## Product Change Notification

1. ECN #: 270120

- PET - PET Power Terminal

- PET-XX-XX-X-RA-XX-FOOTPRINT

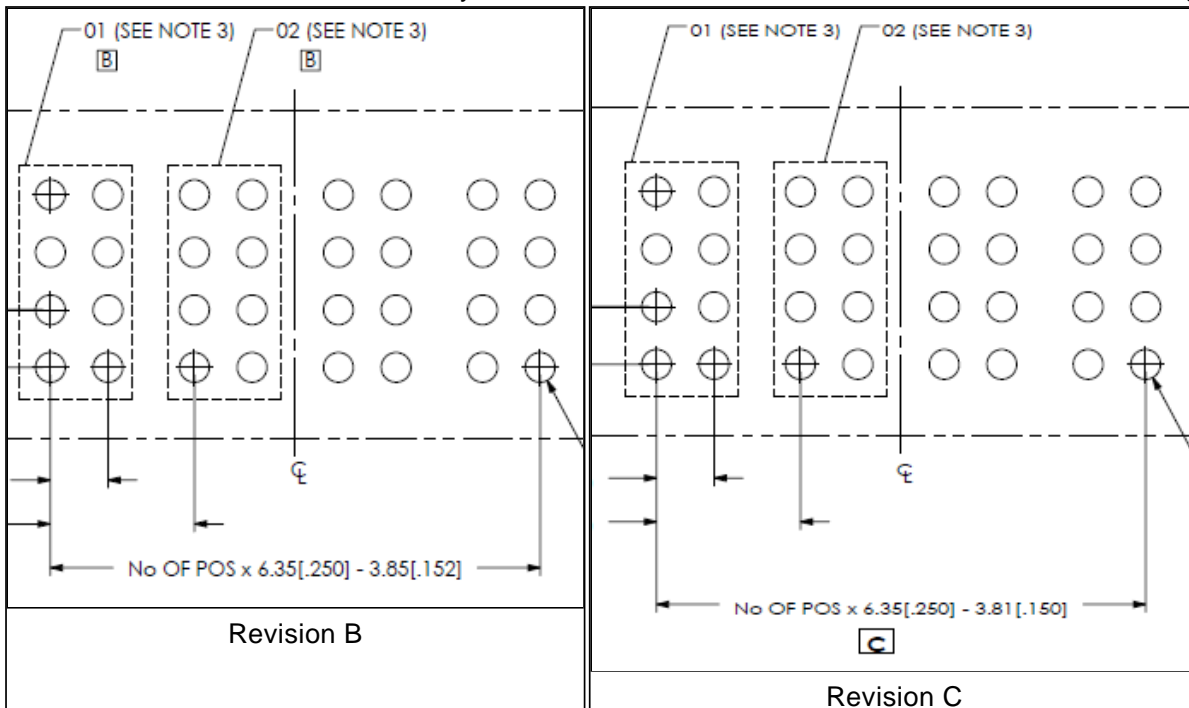
This is an adjustment to the first to last pin calculation to improve the fit of the part to the board.

There is no visual difference. The only difference will be the measurement from first to last through hole.

A recent product review showed that there could be improvement made to Samtec's recommended PCB layout, which would improve the fit of the part to the board. Existing boards will not cause any conflict, and can be used with boards that contain updated footprint.

- Fit - Changing dimension of first to last pin location
